NOTICE OF MEETING

The City of Lake Elmo
Planning Commission will conduct a meeting on
Monday August 9, 2021
at 7:00 p.m.

**City of Lake Elmo
Planning Commission Meeting
Minutes of July 26, 2021**

1.01 OF 28

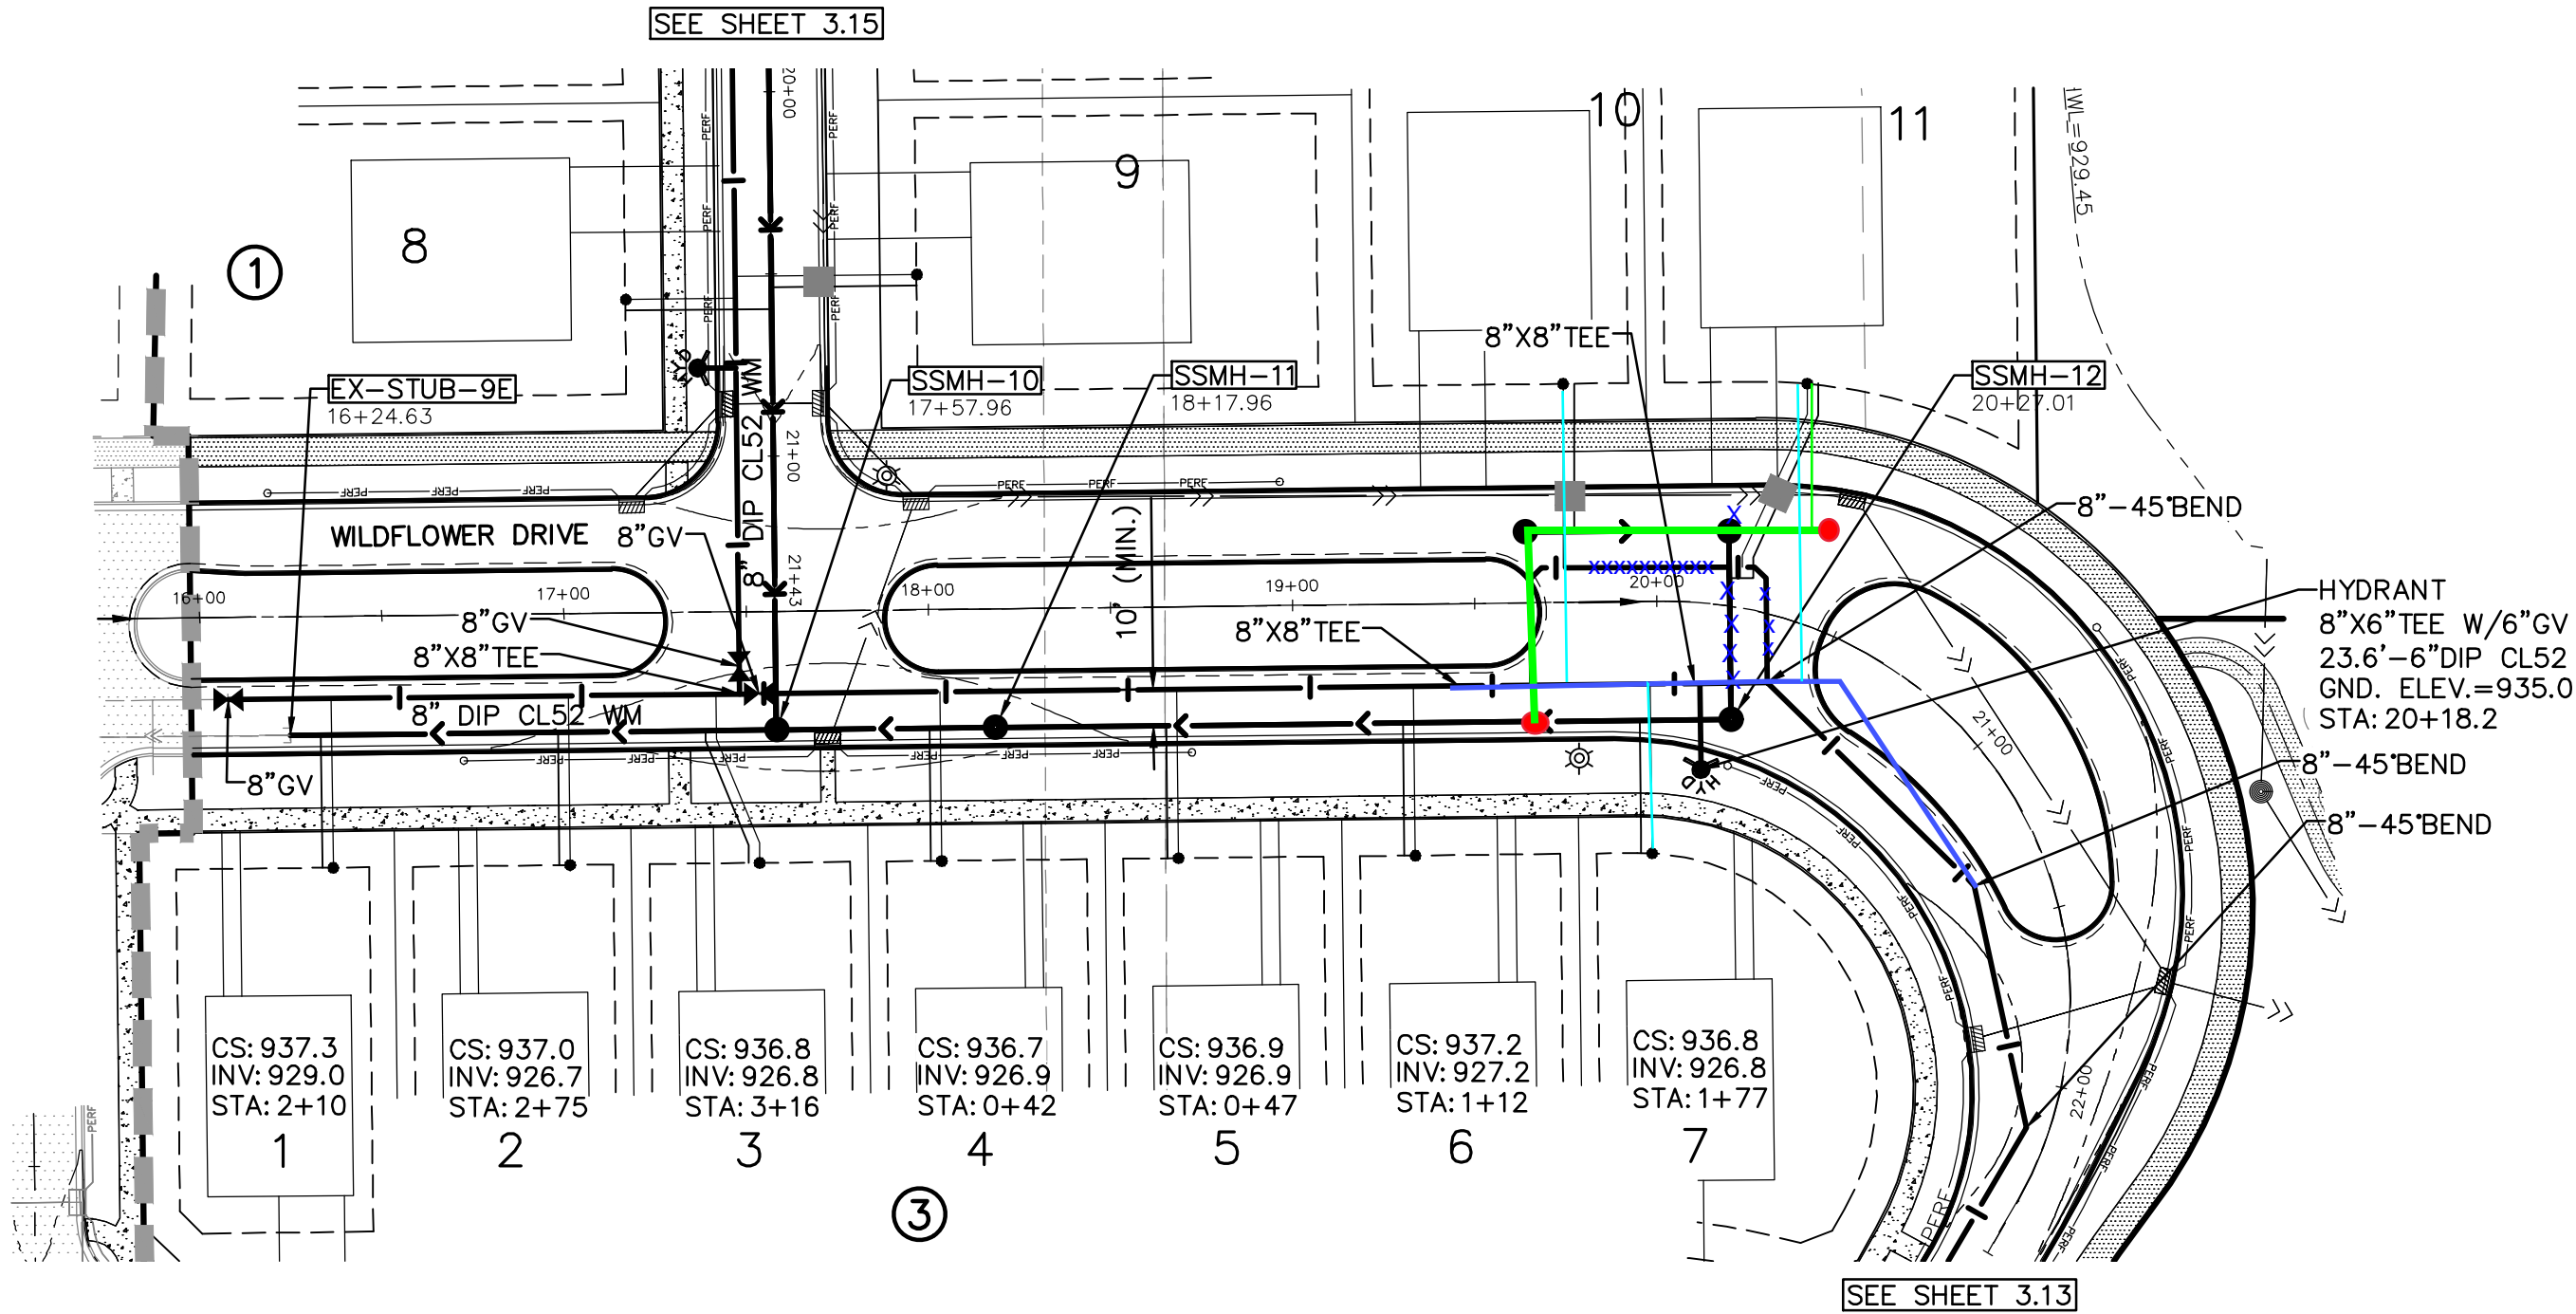
- Sheet 1.01. Add plan note to identify the standard of care guideline for the collection and depiction of existing subsurface utility data per CI/ASCE 38-02.
- All plan sheets: Revise Outlot boundaries and naming to Wildflower 4th Addition naming structure.

3.14 OF 28

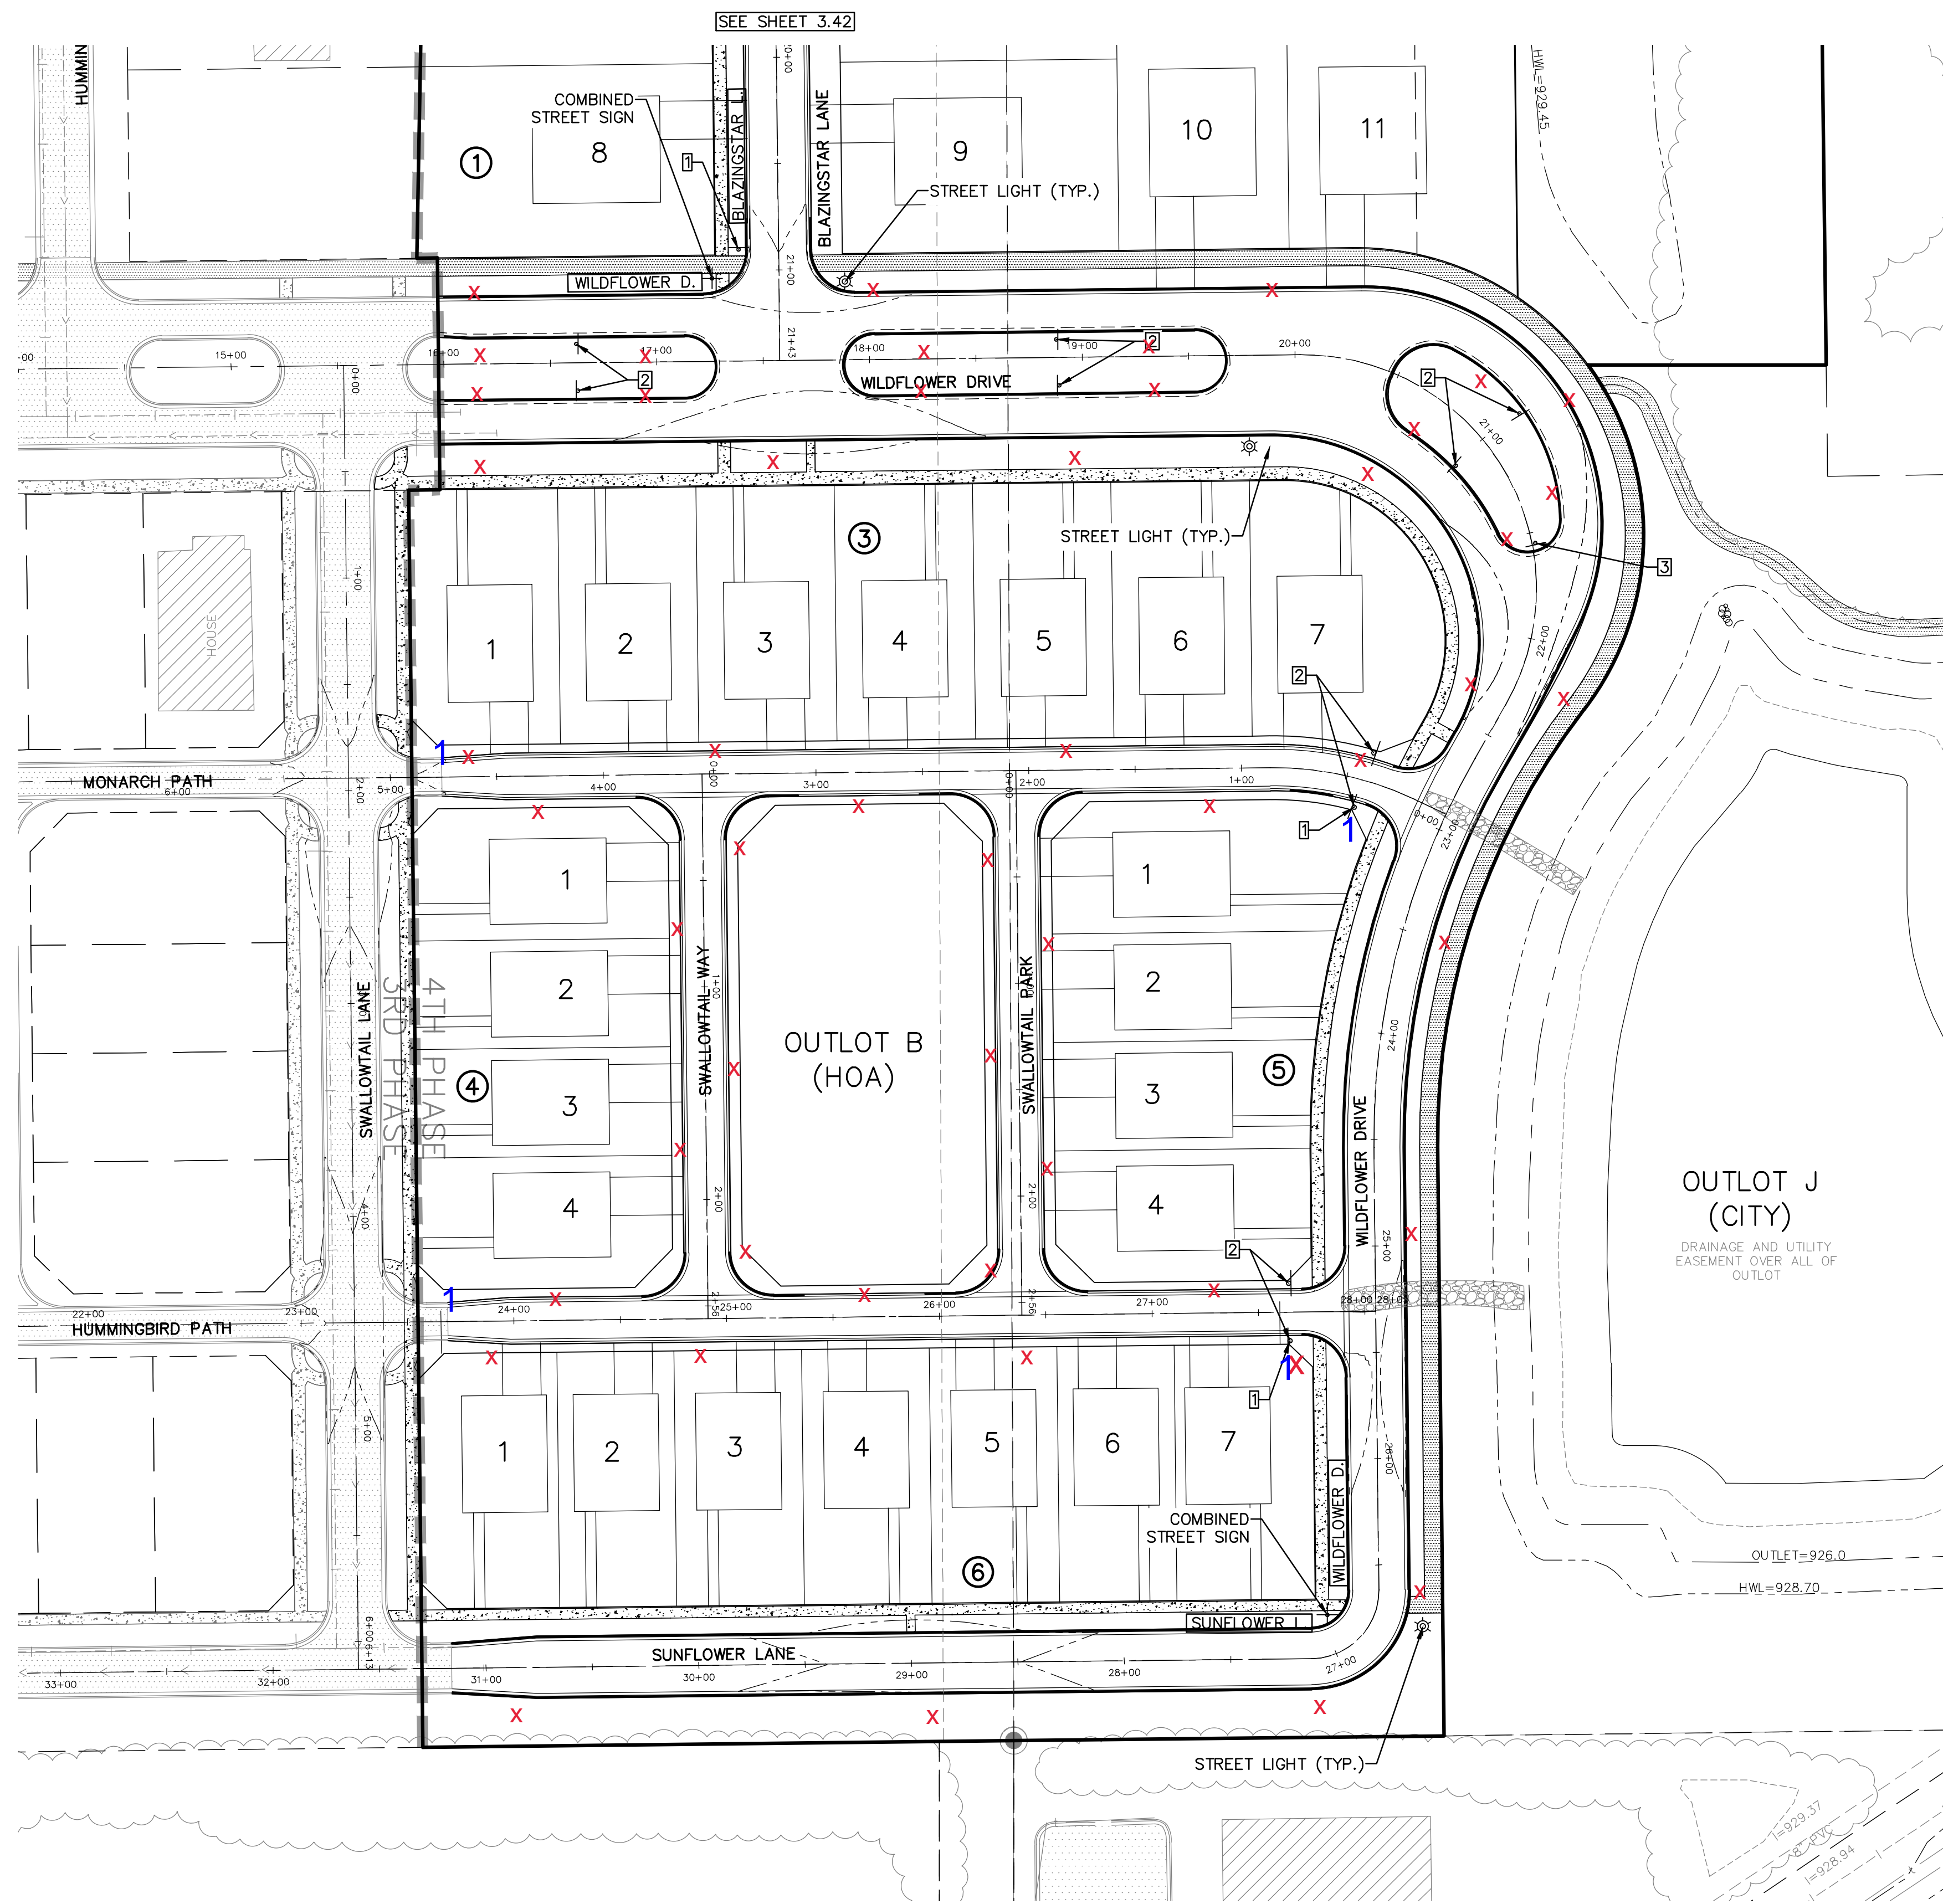
- Sheet 3.13. Revise services for Lots 1-3, B5 to remove all bends.
- Sheet 3.14. Revise services for Lot 3, B3 to remove all bends.
- Sheet 3.14. Revise water/sewer layout and services for Lot 7, B3 and Lots 10-11, B2 per the attached edits.
